REMARKS

AHURA-1

MMS/AHURA1.AMD

Fig. 1 - Normalized Raman Gain Spectrum of standard single mode fiber. Pump wavelength is at 1450 nm.

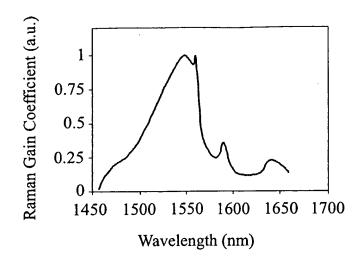
- (1) indicated that Figures 1-9 should be designated by a legend such as "Prior Art" because only that which is old is illustrated;
- (2) objected to the drawings as failing to comply with 37 CFR 1.84(p)(5) because they include the following reference characters not mentioned in the description: 206I, 206K, 212I, 212K and 312;

Annotated Market - up Smeet

In response to Item 1 above, Applicants have amended Figs. 1-4 to add the legend "Prior Art" because only that which is old is illustrated.

PRIOR ART

Fig. 2 - Distributed Raman amplification using forward pump (co propagating pump and signal). The noise of pump and signal beams are schematically drawn.

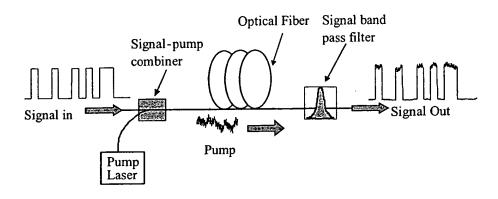
Annotated Marked-up Sheet

PRIOR HRT

Fig. 3 - RIN transfer spectrum for a co- and counter-pumped Raman amplifier with 10 dB of gain. Pump attentuation = 0.29 dB/km, length = 10km (solid line) and 80km (dotted line), dispersion = 15.6 ps.nm km⁻¹, pump at 1455 nm and signal at 1555 nm [5].

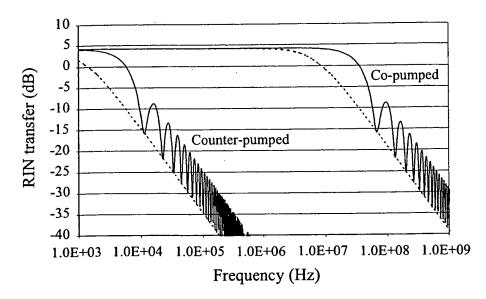
Annotated Marked-up Sheet

PRIOR fret

Fig. 4 - Power evolution of pump diode lasers along the fiber path. The pump wavelengths are: 1420 nm, 1450 nm, 1480 nm and 1510 nm. The longer wavelength pump (1510 nm) is amplified by short wavelength pumps.

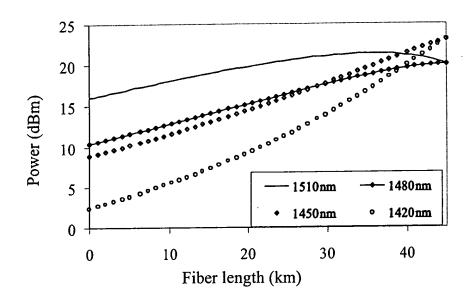
Annotated Marked-up Sheet

PRIOR ART
